Alaska DMT Software Revision 3.00 Evaluation

December 3, 2013

100397 was used in the evaluation

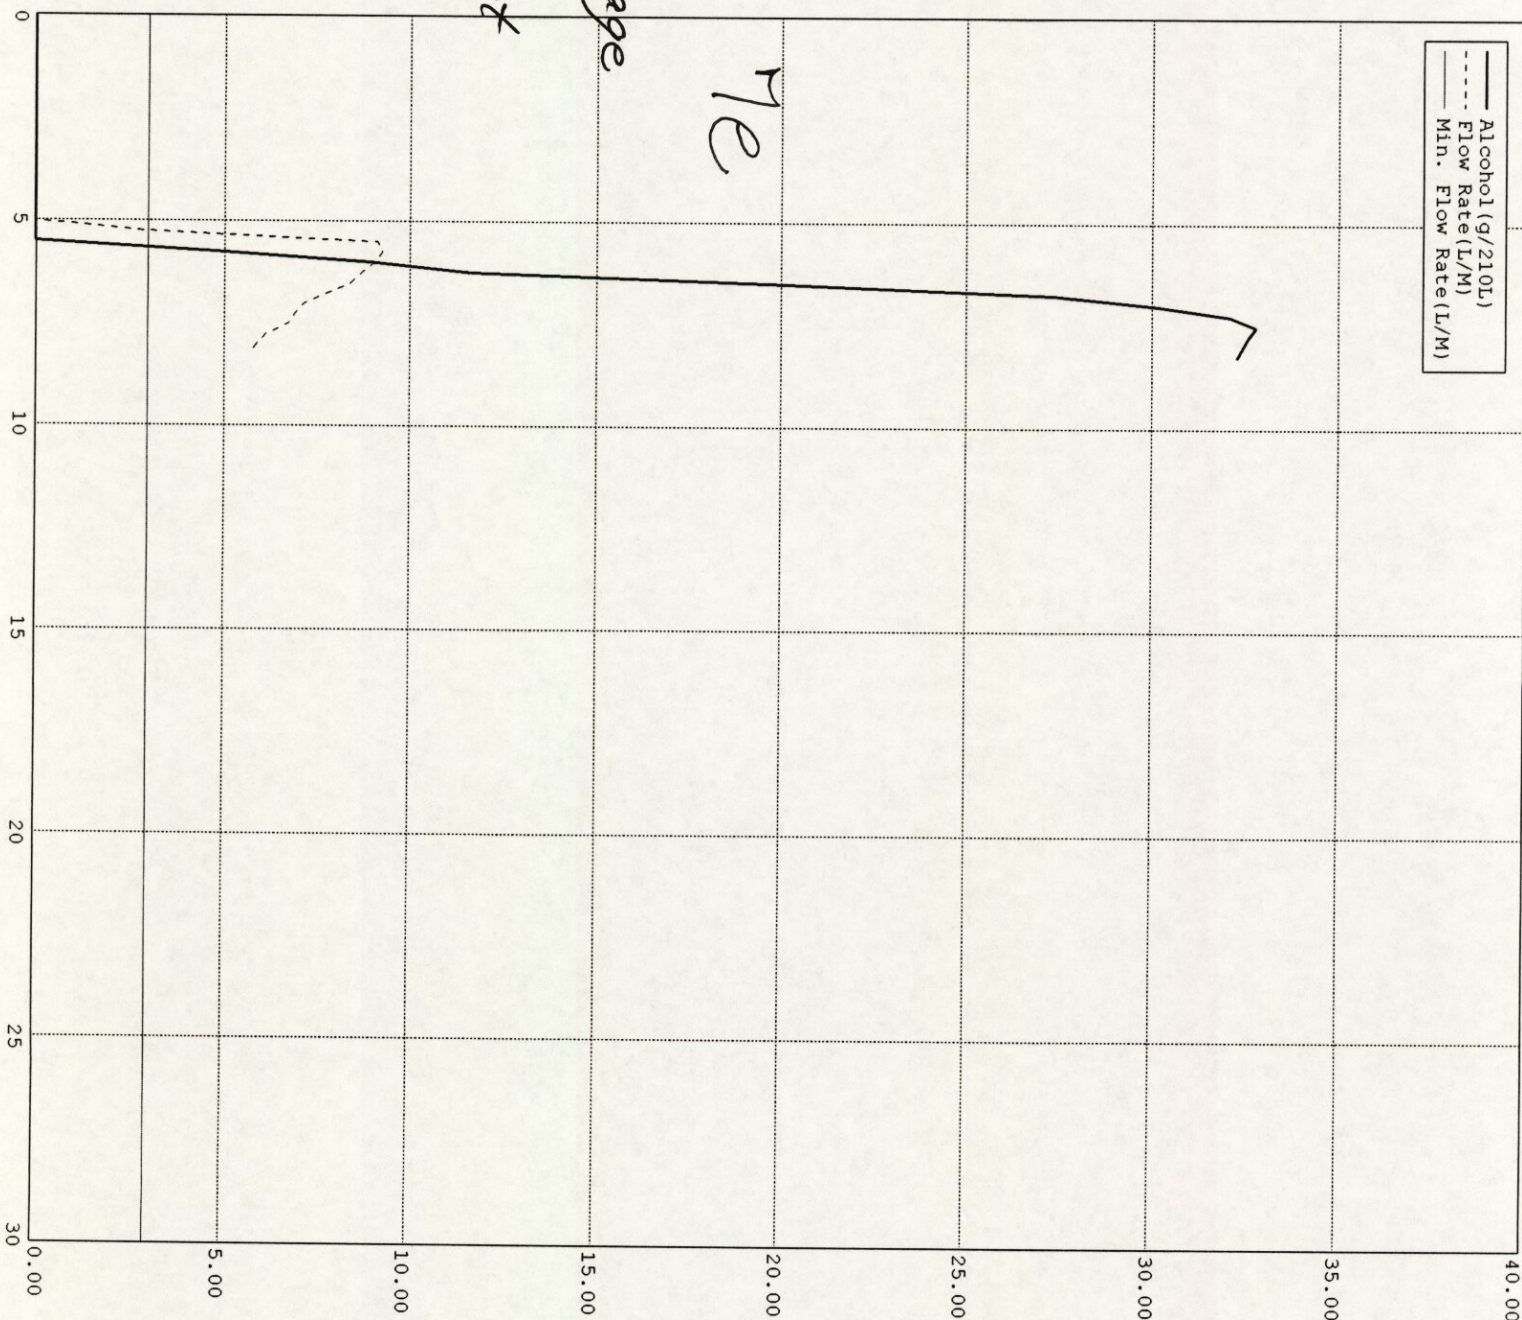
- o confirmed invalid status message
- the + retest adding
- o confirmed the for subject test result on the screen.
- o confirmed signature the

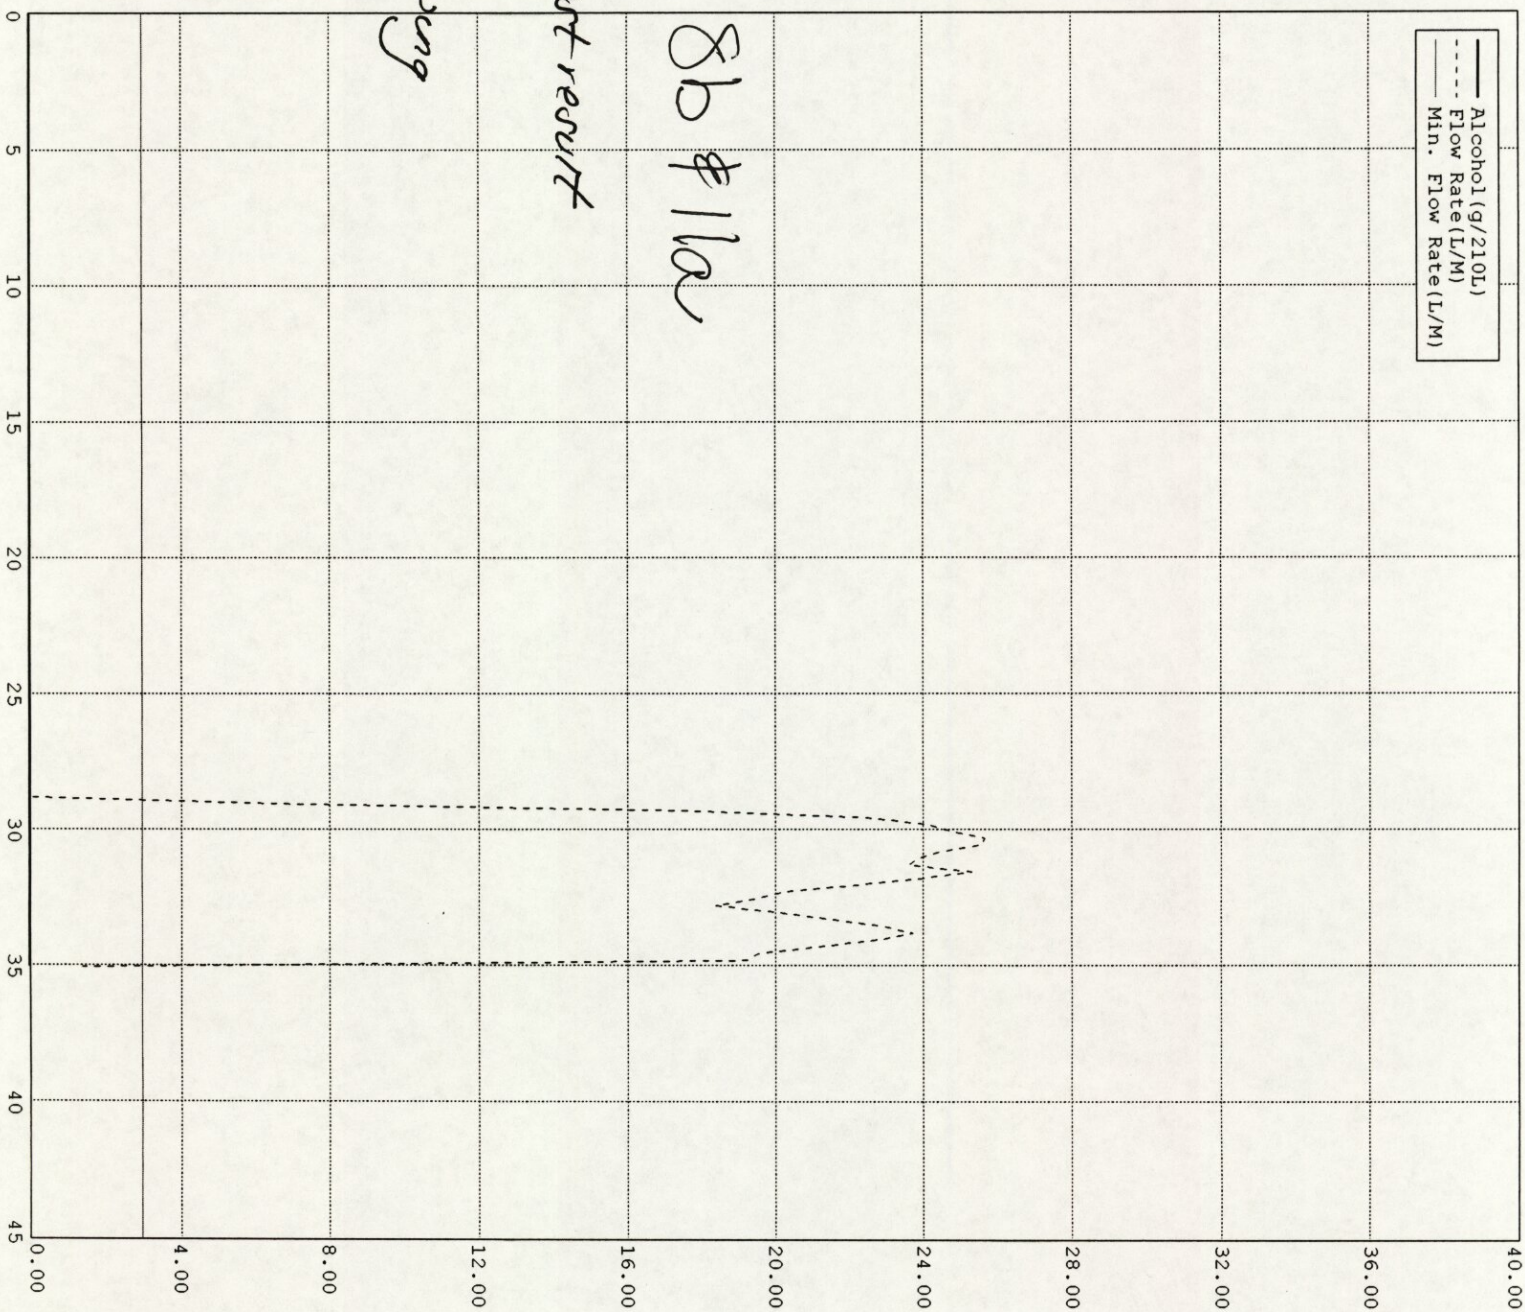
- Confirmed xx for subject test result with non-completed test
- Confirmed blank error following subject test

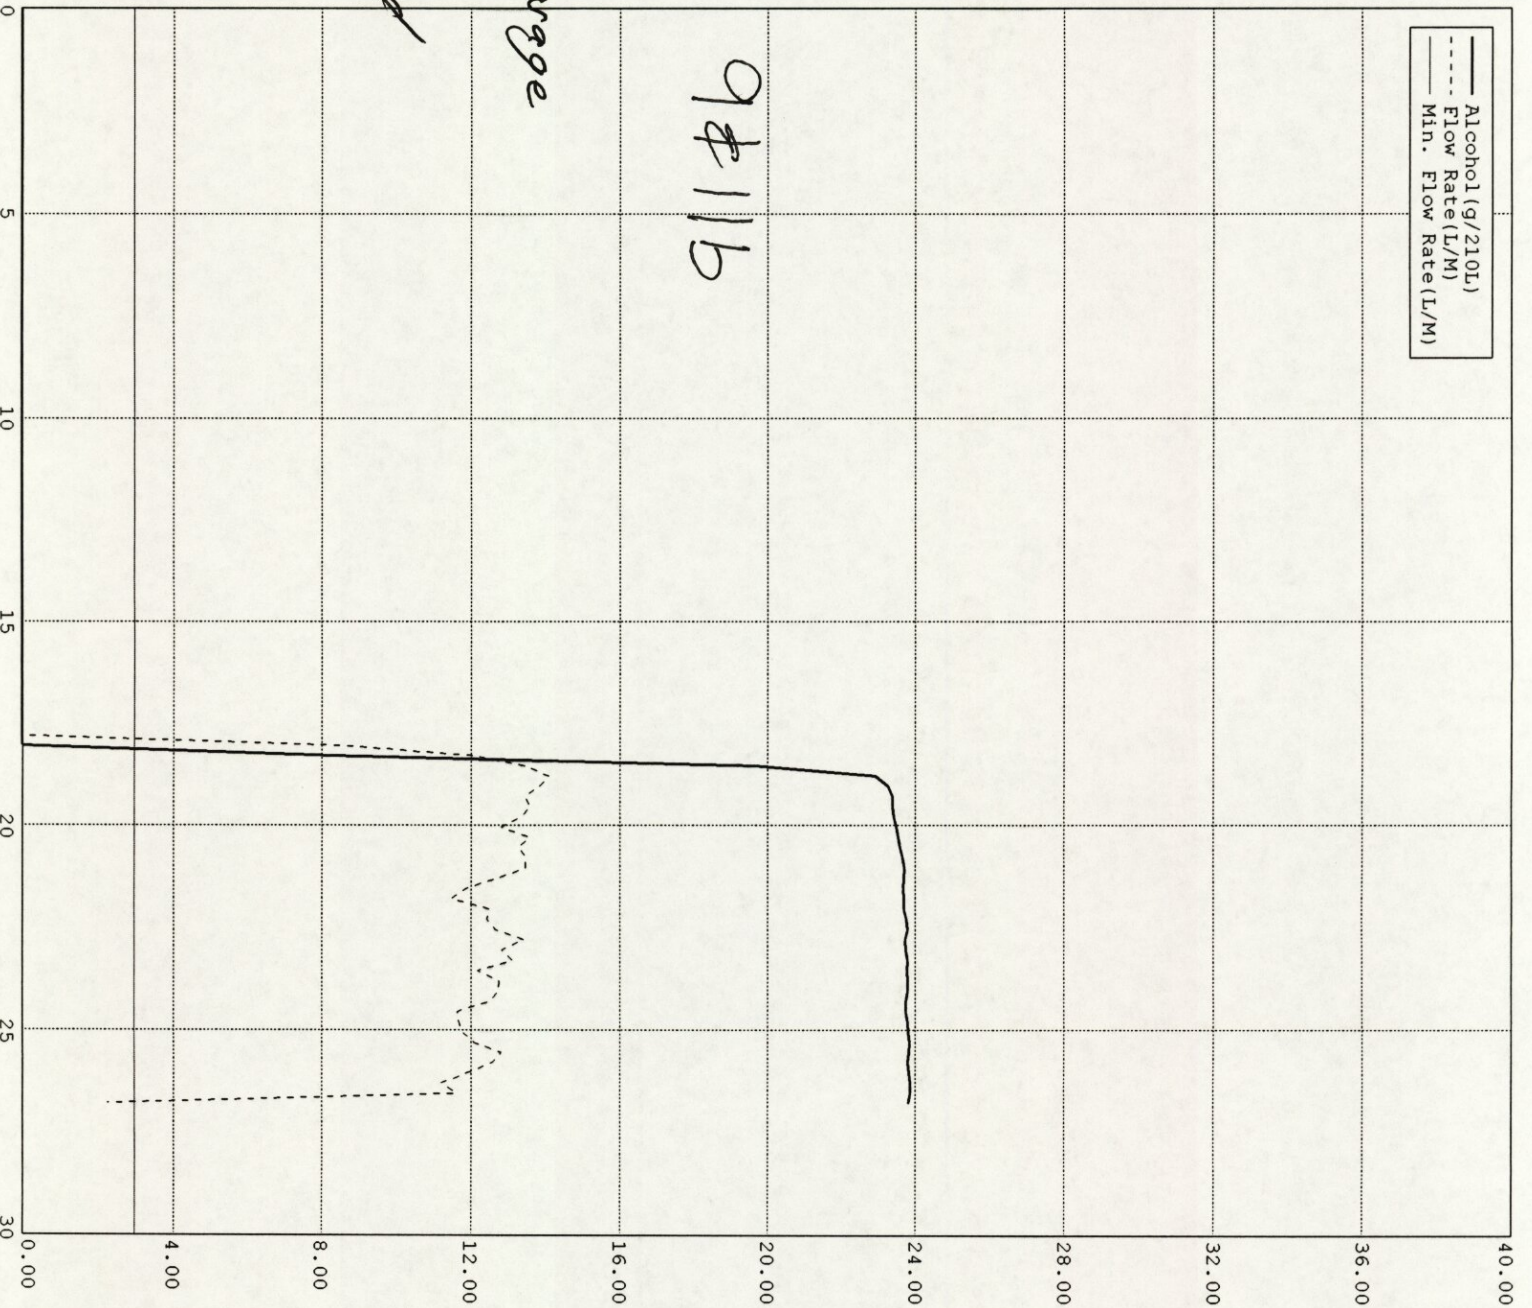
- Confirmed Interference message
- by
- confirmed rx for non-completed
- subject tests,
- confirmed signature block

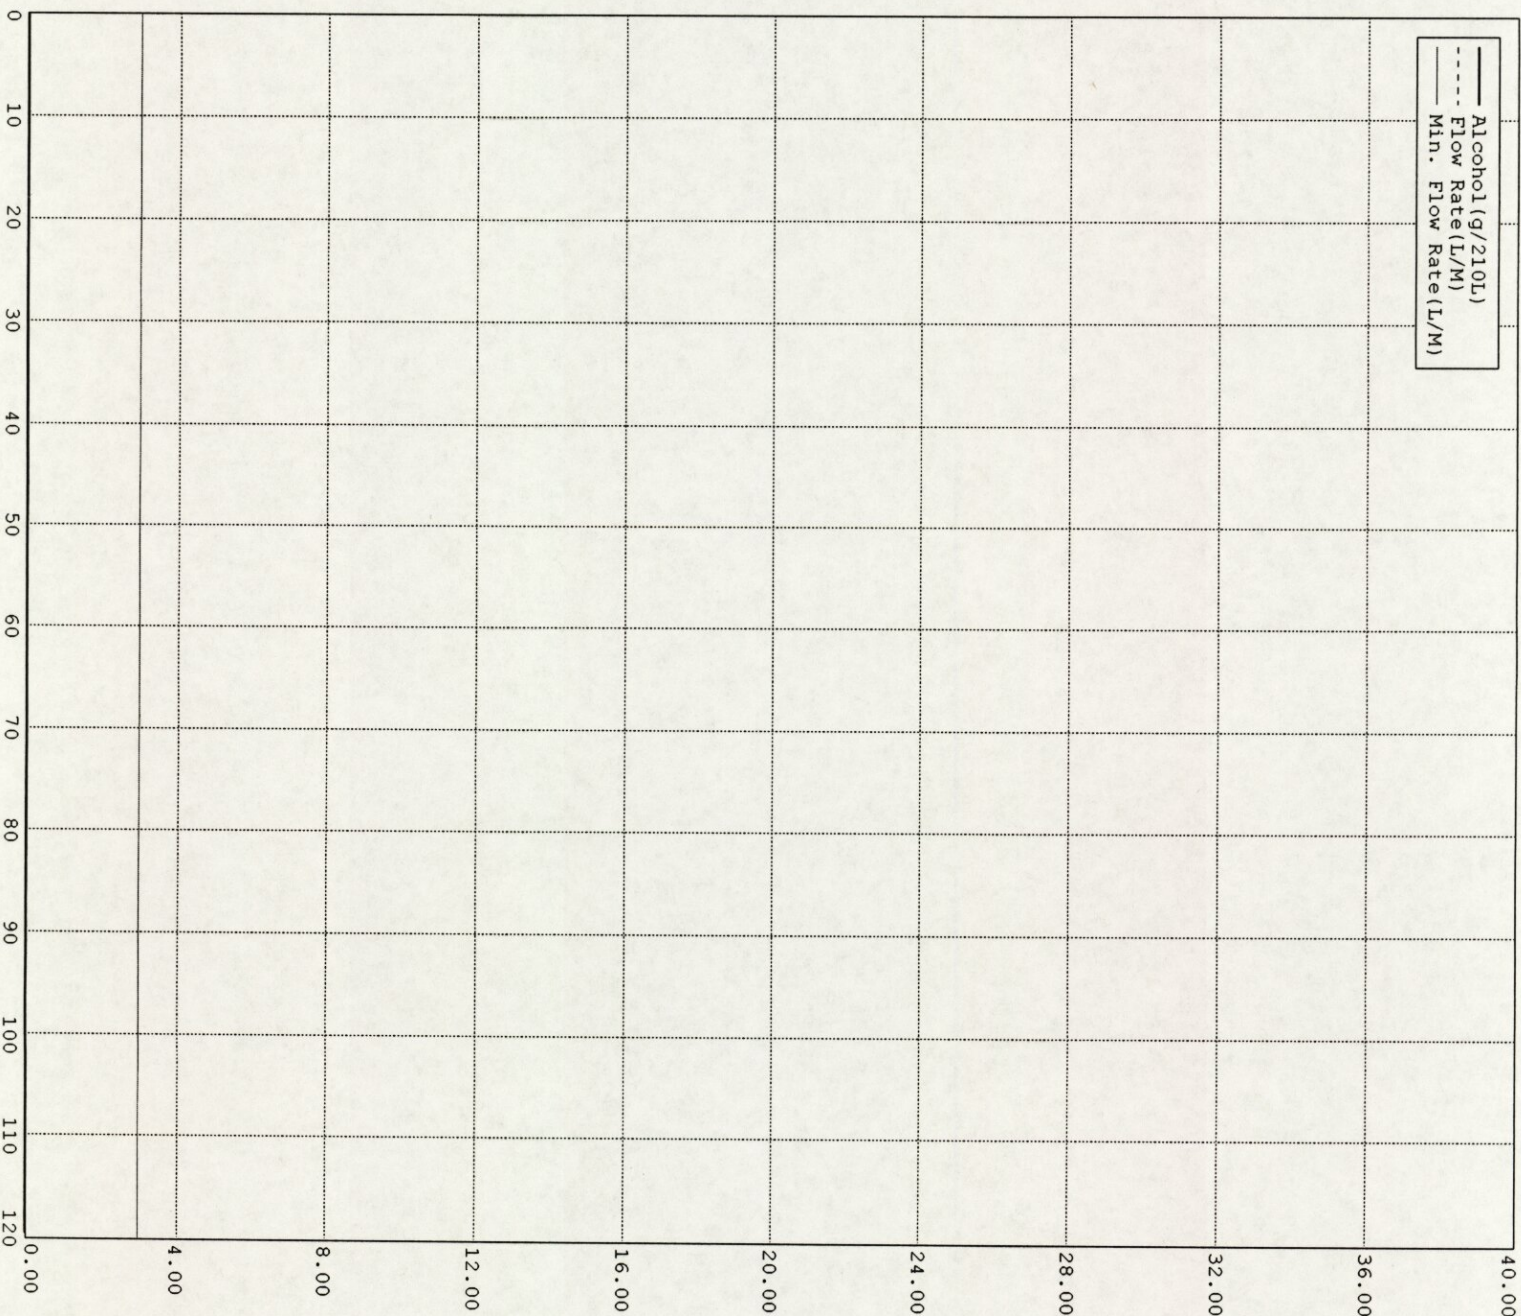
*Refusal Query on
 No to refusal
 Confirmed result*
